Access Compliance Report

Public Rights-of-Way

(Pedestrian Signals)

Intersection ID: N/A	Main Street:	Cross Street: N/A	Location: N/A
ADA ID: 66E5B8CBBA65	Signal Type: Two Push Buttons-APS	Overall Compliance: No	Severity Score: BTN 1:N/A BTN 2: N/A No BTN: N/A
Codes/Mitigation Info/Possible Solution		Field Measurements/Component Compliance

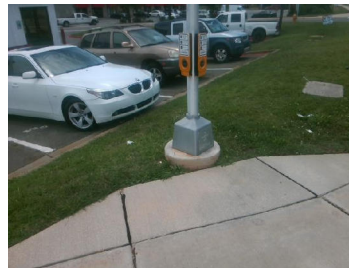
Surveyor Notes: TEXT HT 5/16

PROW/ADA: R410.6, TMUTCD 4e.08, R406.2, , R209.1, R404.2, R404.7.3

Possible Solutions: Replace Signal Push Button With APS Button on New Post. Remove & Replace Sign.
